CITY OF ALBUQUERQUE

**RE: Sunset Memorial Park Pueblo Esperanza Phase 2
924 Menaul NE
Grading and Drainage Plan
Engineers Stamp Date 12/7/15 (H15D016)**

GRADING PLAN

PUEBLO ESPERANZA - PHASE 2A
 SUNSET MEMORIAL PARK

C-2

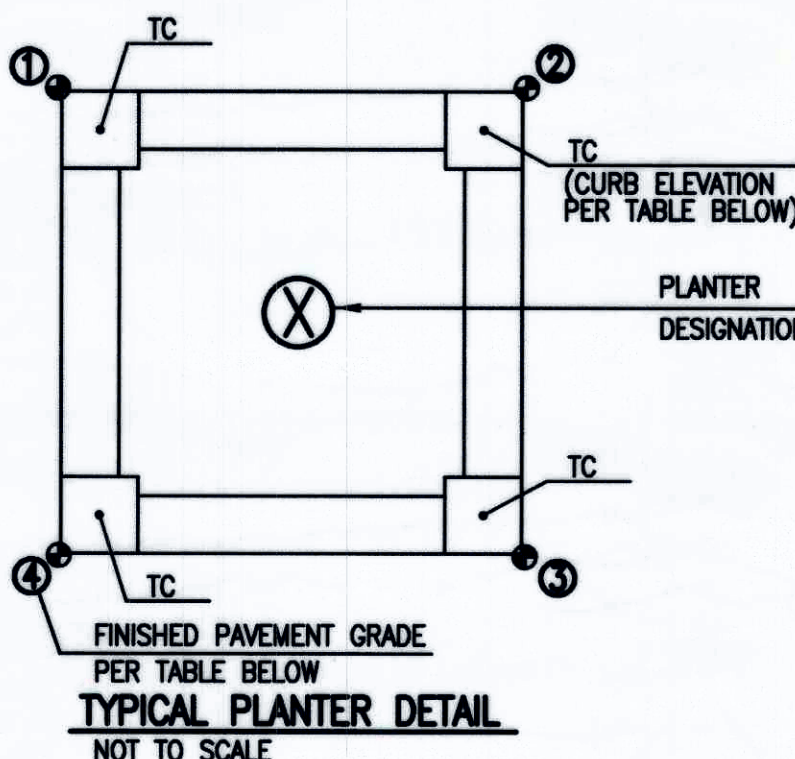
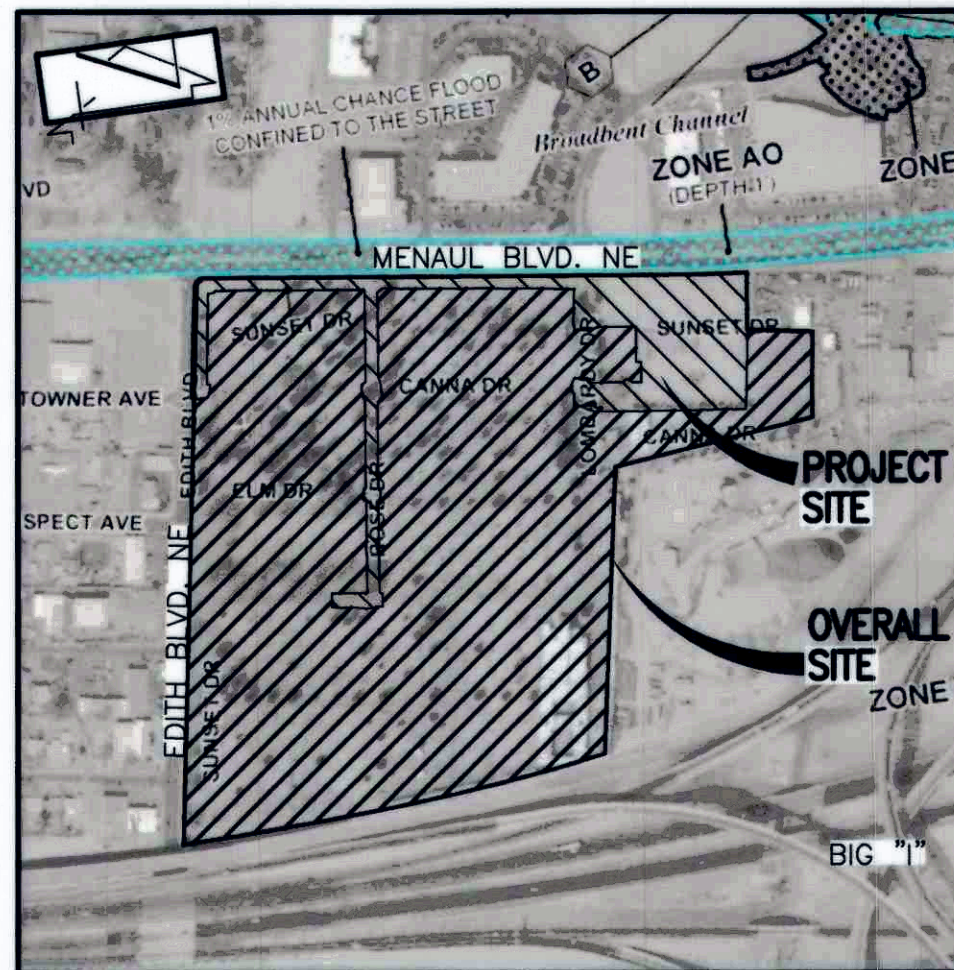
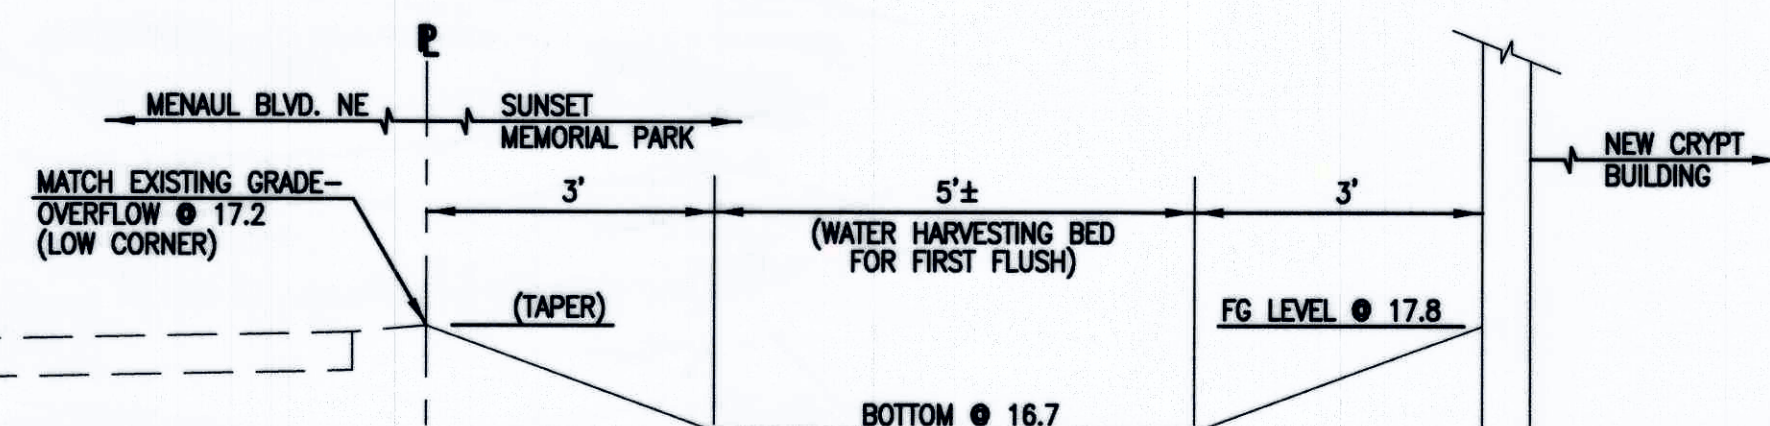
Based upon the information provided in your submittal received 12/7/15, this plan is approved for Building Permit. Please attach a copy of this approved plan to the construction sets in the permitting process prior to sign-off by Hydrology.

Prior to Certificate of Occupancy release, Engineer Certification per the DPM checklist will be required.
